ISLAND AVENUE
109B-T-50

APPLICATION FOR PERMIT

Permit to construct 8 x 24 addition on ground floor, 42x20 addition on the second floor as per plans 2 sheets

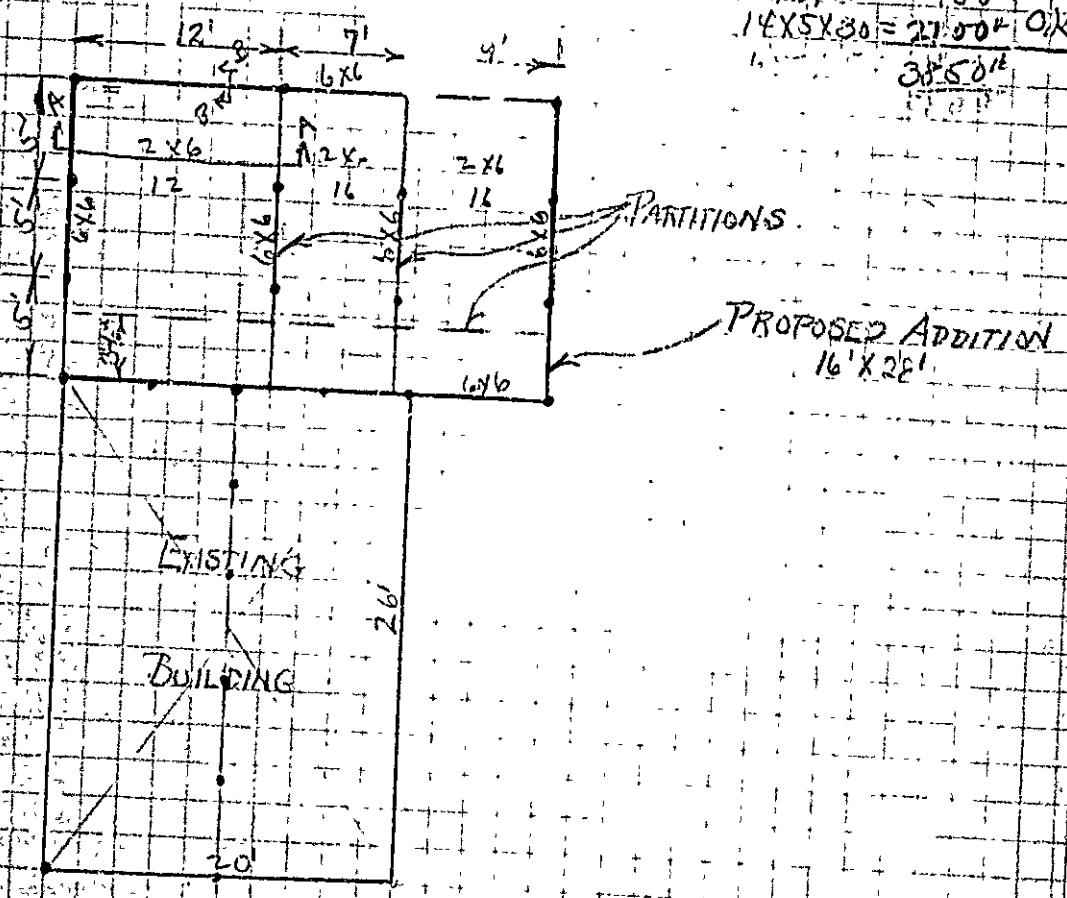
$$2 \times 6 = 12 \frac{1}{2} \text{ span} = 524''$$

$$6 \times 6 = 8 \frac{1}{2} \text{ span} = 2542''$$

$$6 \times 6 = 5 \frac{1}{2} \text{ span} = 4067''$$
